**ChiCycle Believe Proposed Modifications to Pavements Near the Chichester Mini Roundabout at the Intersection Between Sherbourne Rd and Westgate will Contravene the Equality Act 2010**

Report compiled by Mark Record June 2021

Outline Planning Permission for Phase 1 of the Chichester White House Farm development 14/04301/OUT includes legal agreement document (SECTION 106 PLANNING AGREEMENT - 11.04.18 - PART 1 OF 9). Page 98 this document states developers are required to “establish an advisory Infrastructure Steering Group to be managed and led by the County Council”. The purpose of the steering group is to “take forward the preliminary designs for the Highway Works to detailed designs and delivery of the Highways Works prior to their approval by the County Council”.

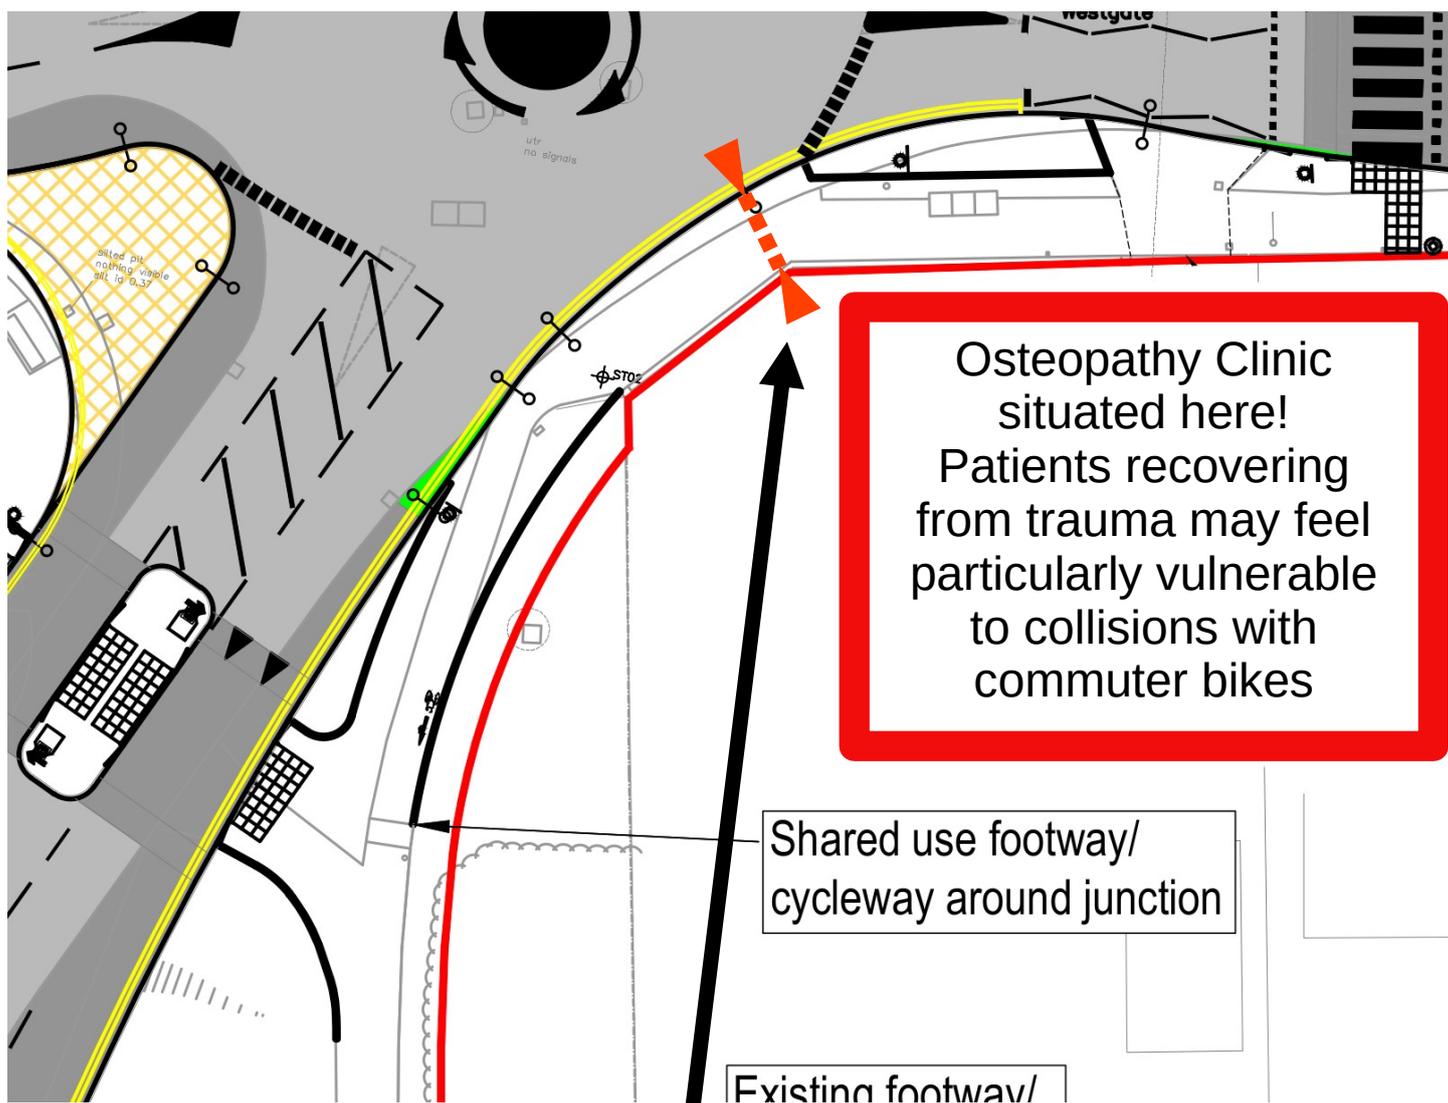
On the south of Westgate, the proposed path width is only 2.8 metres

However, LTN01/20 recommends a 3.7 metre width shared track at this location to comply with current guideline widths.

The proposed width of this shared use cycle track is only **75%** of the minimum width recommended by DfT!

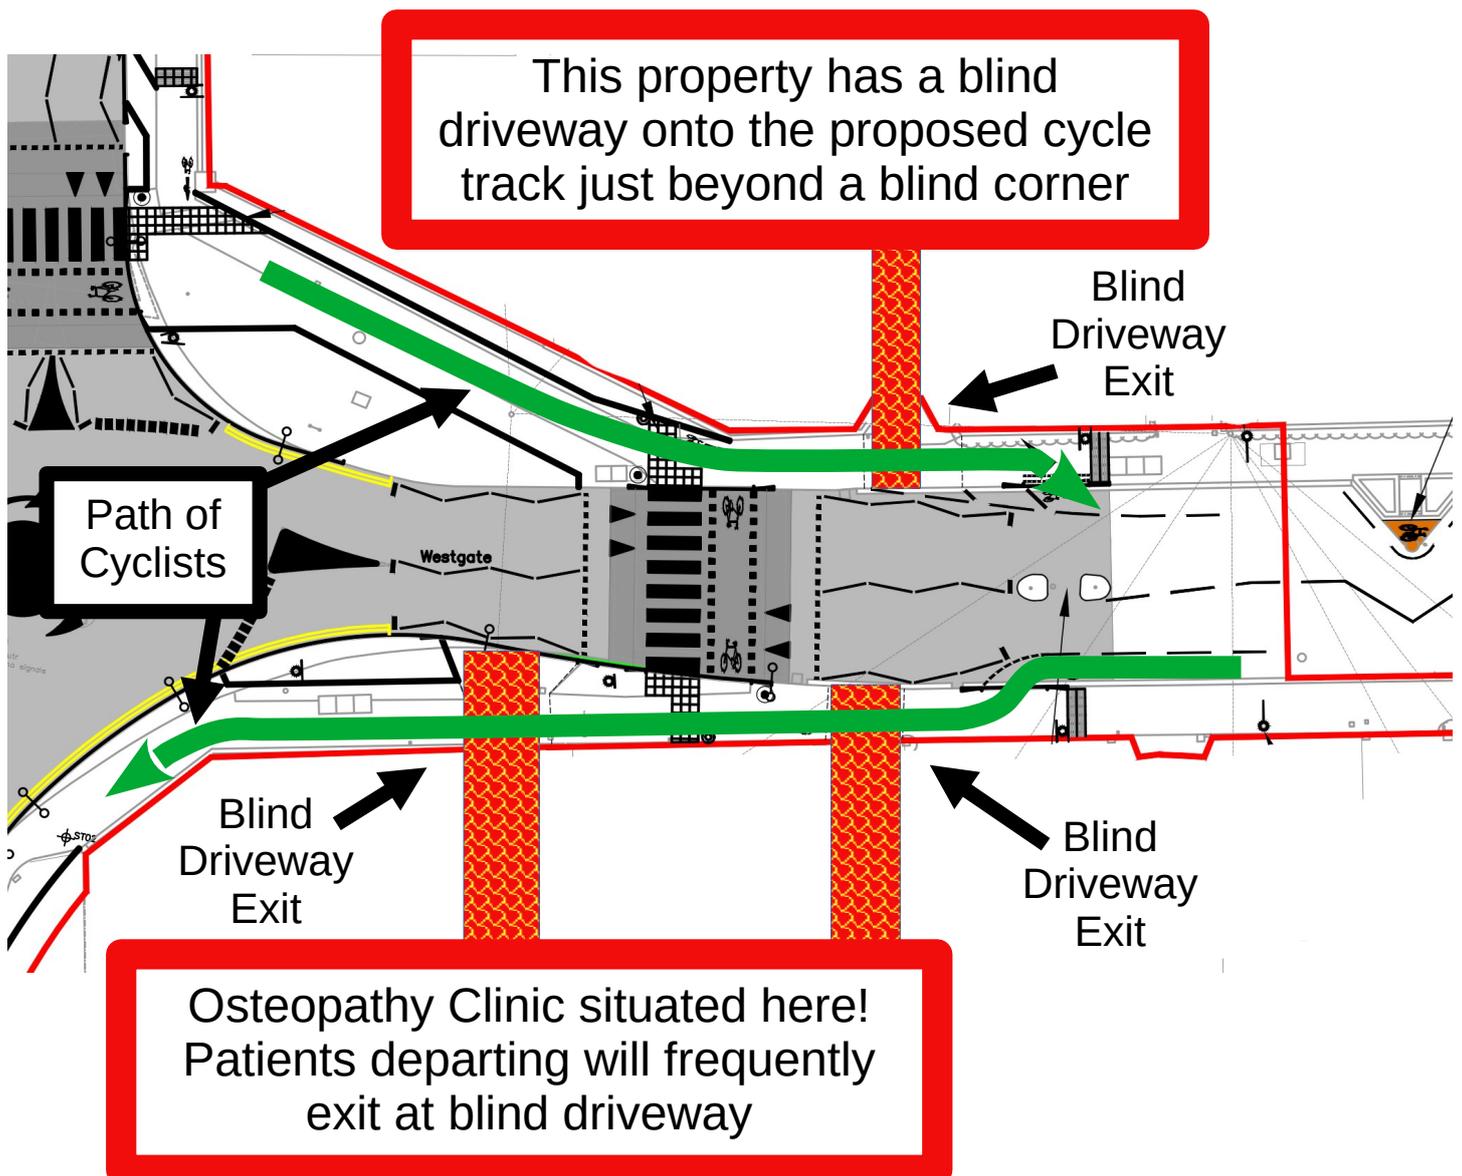
The proposed shared use cycle tracks will induce conflict between pedestrians and cyclists. This will be exacerbated by cyclists suddenly swerving to avoid cars emerging from blind driveways.

By contrast, the proposed cycle-track sections for Westgate permit only limited forward visibility as there is no clear space maintained at the inside edge of the pavement. With growing adoption of silent electric vehicles it will be impossible for cyclists to hear engine noise alerting them to emerging vehicles. Unless assistance is available to help guide vehicles safely out of these driveways, residents will be left with no choice but to edge out across a stream of cycle traffic that they cannot see or hear approaching.

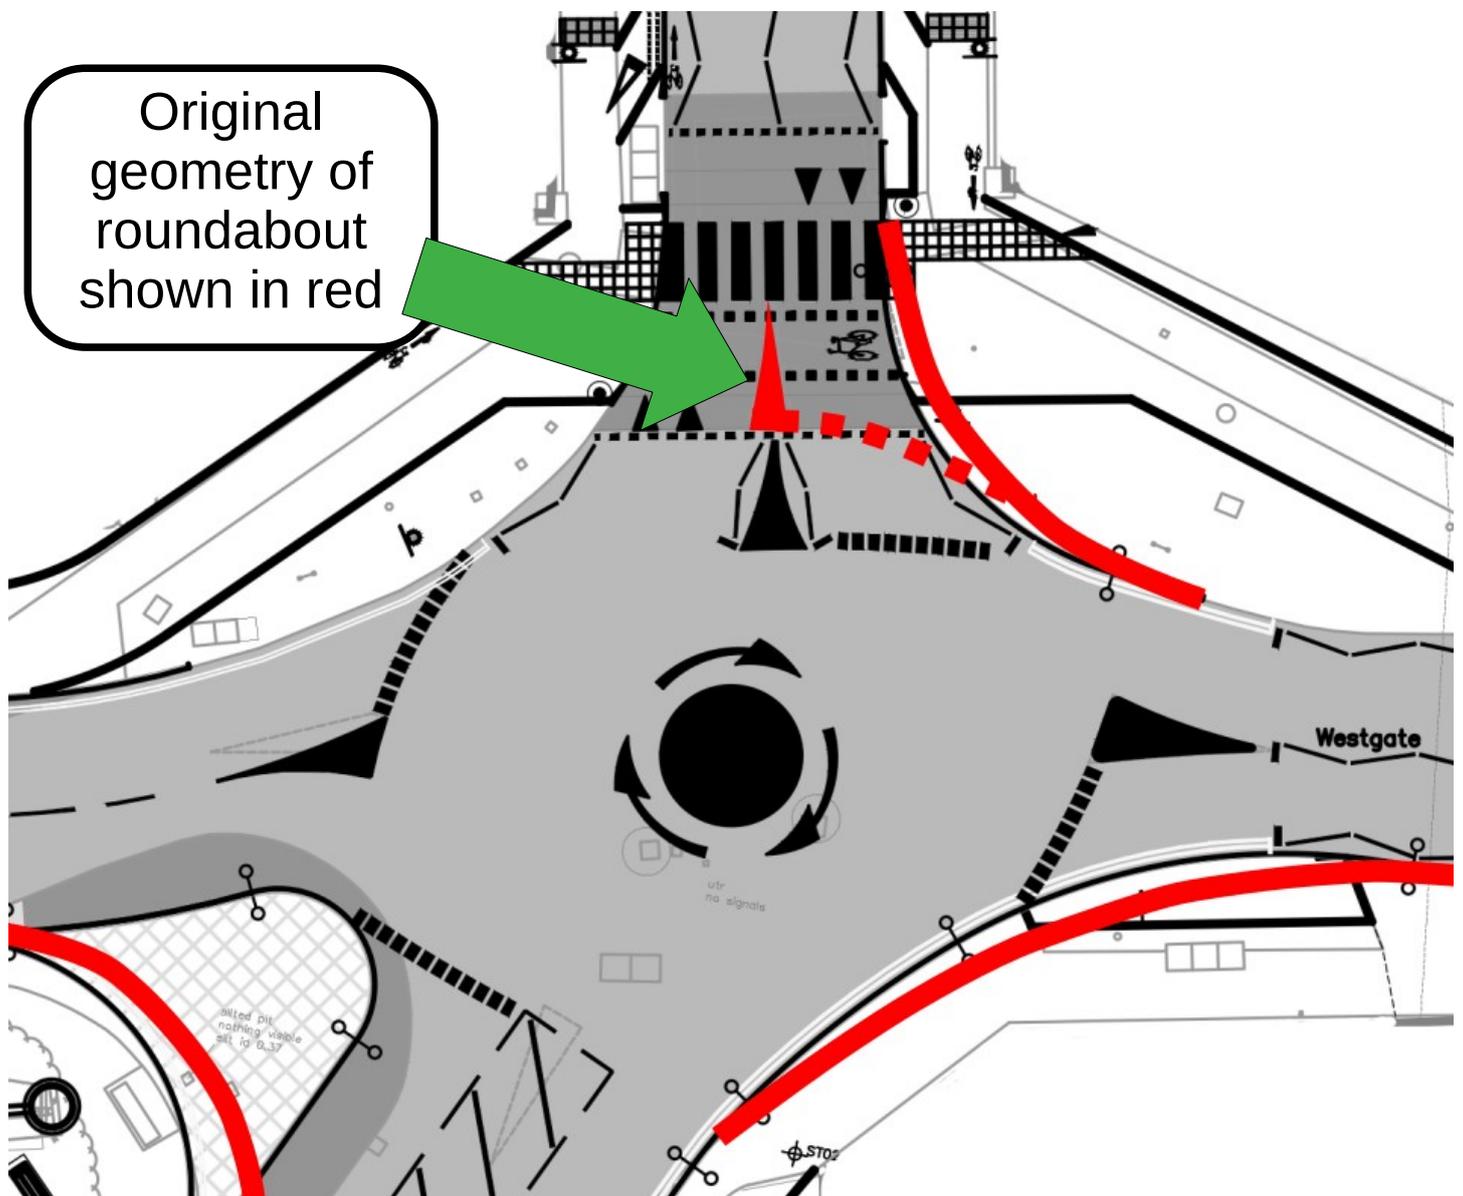
Unless the owners of these driveways remove their hedges and reduce the height of their front garden walls, emerging cars have no visibility of approaching traffic on this pavement when it is converted into a cycle track! Again, the proposals do not explain if cyclists or emerging cars have priority at these driveways.

The second driveway shown above is the entrance and exit of a busy osteopathy clinic on the south side of Westgate at the roundabout. Clients of this clinic may not realise the pavement has been converted into a shared cycle-track making collisions with cyclists likely. Cyclists knocked off balance by emerging cars are then likely to collide with vulnerable pedestrians.

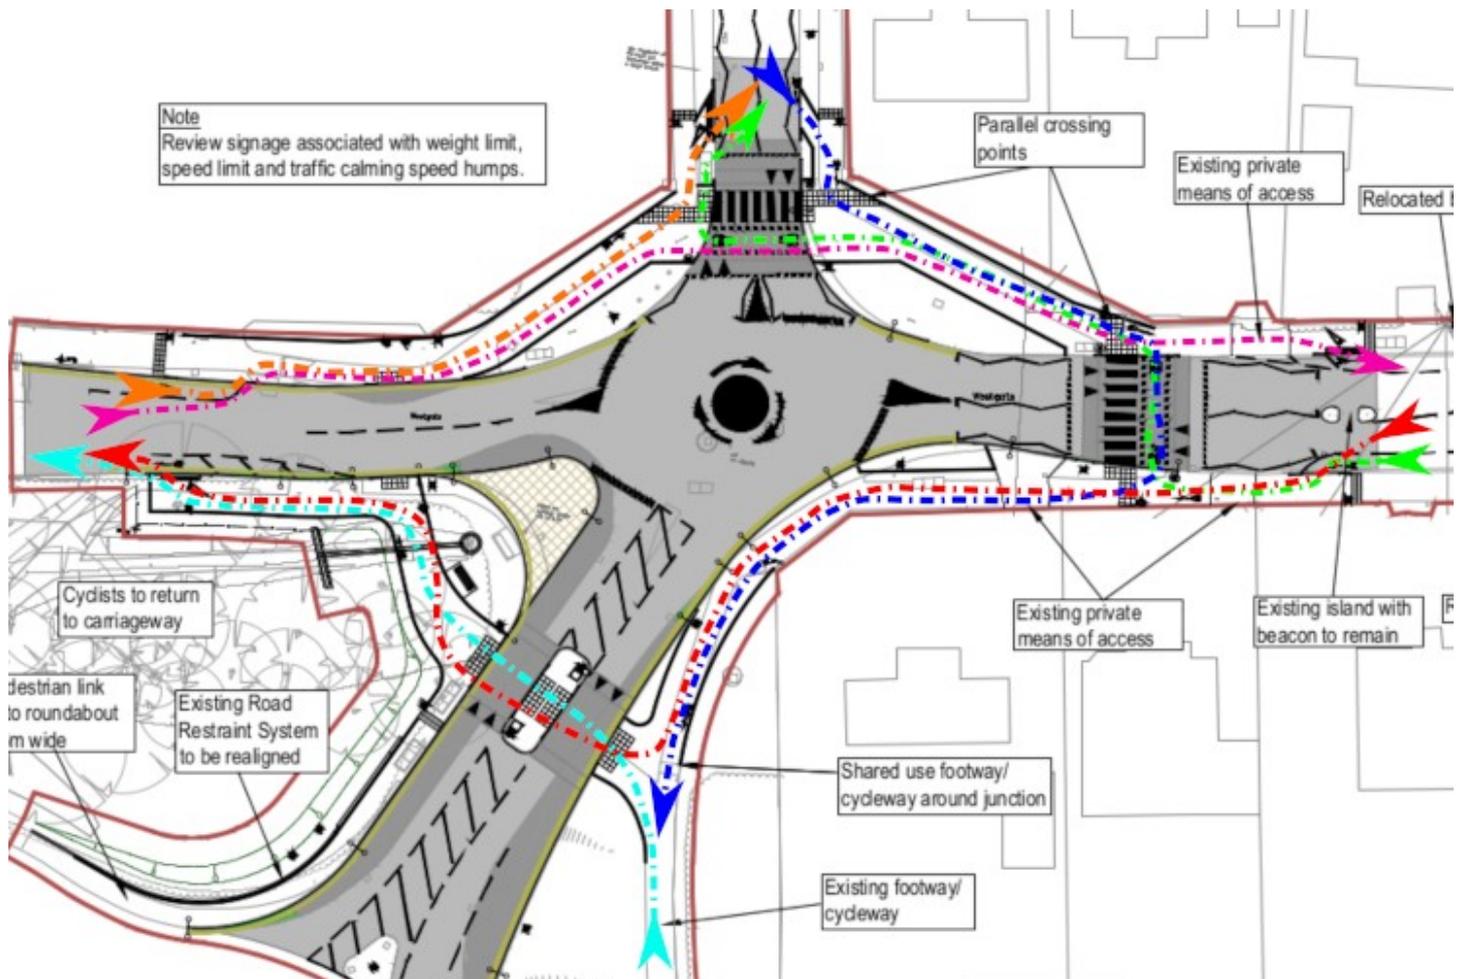
The coloured lines in the diagram (shown below) represent paths and desire lines that cyclists are likely to follow after the proposed conversion of the footways into shared use cycle-tracks.

This design will result in conflict that will particularly disadvantage vulnerable pedestrians. Parents pushing prams or holding a child's hand, elderly or disabled pedestrians will be unable to avoid walking on narrow shared use cycle-tracks if they need to negotiate this junction.

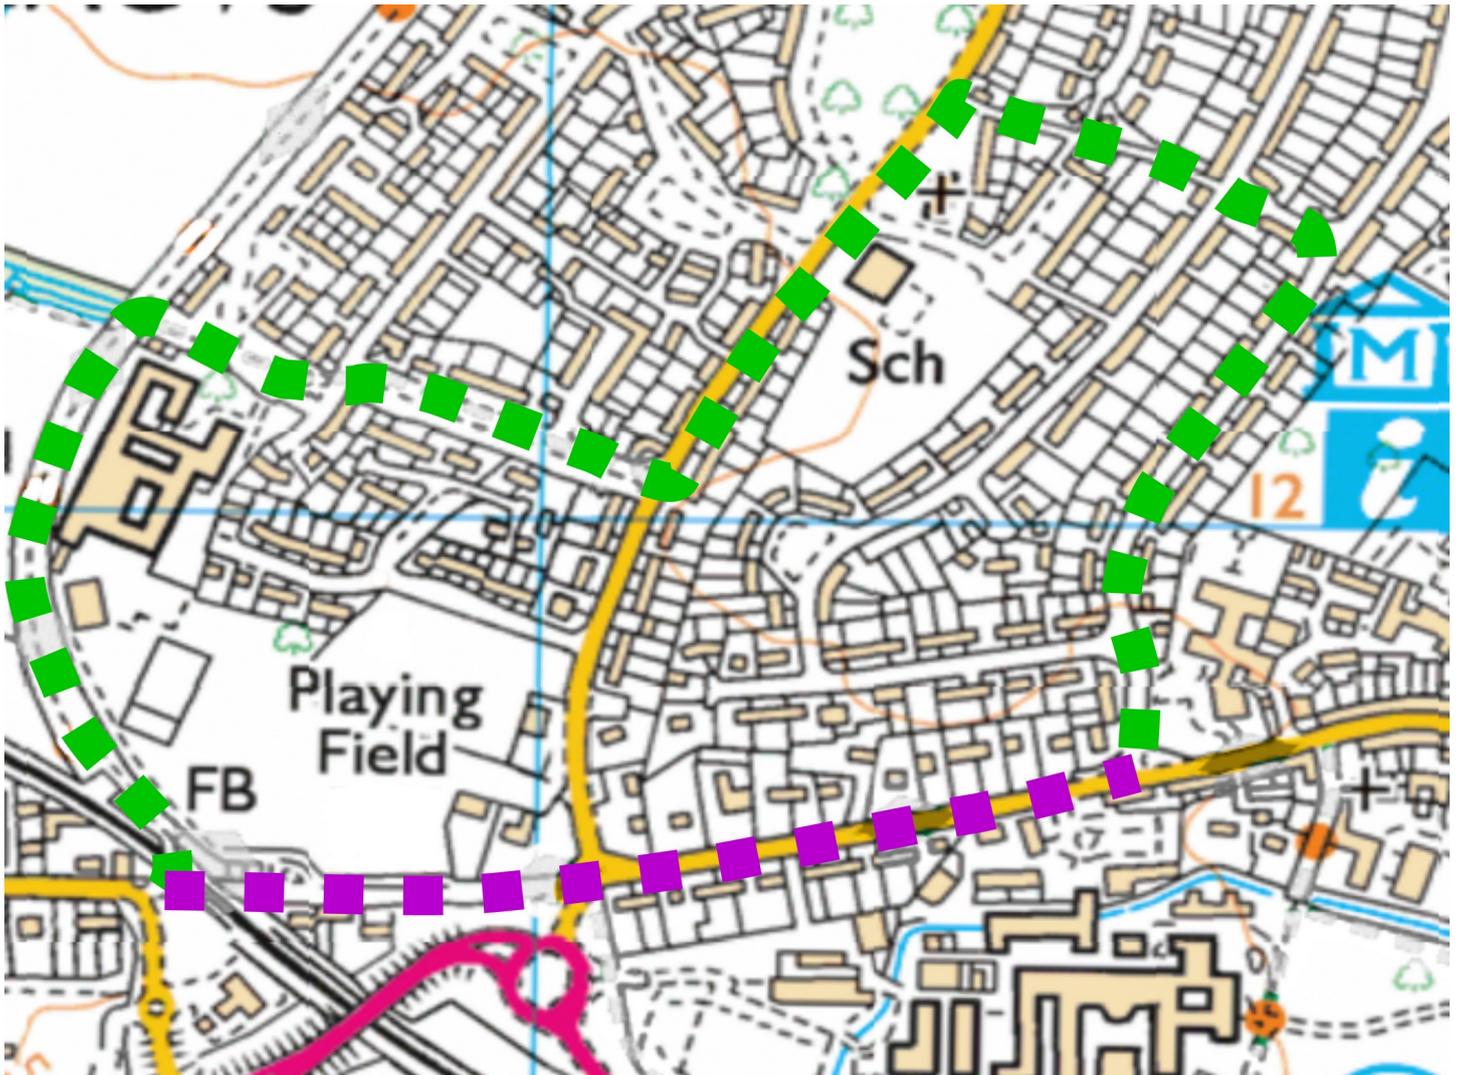
The purple dots in the diagram show the existing pedestrian route from the railway foot bridge at Bishop Luffa school towards the Market Cross. If the proposed scheme goes ahead, elderly, disabled pedestrians who fear collision with bikes will have to take a long detour to use alternative, safe pavements and paths. The shortest realistic alternative route is shown by the green dotted line.

The green route that would avoid conflict with bikes on narrow shared use pavements, is over **1.15 km longer** than the direct route shown in purple. The Centurion Way mostly complies with existing DfT standards so it is possible some elderly or disabled pedestrians might be confident walking the route shown by green dots.
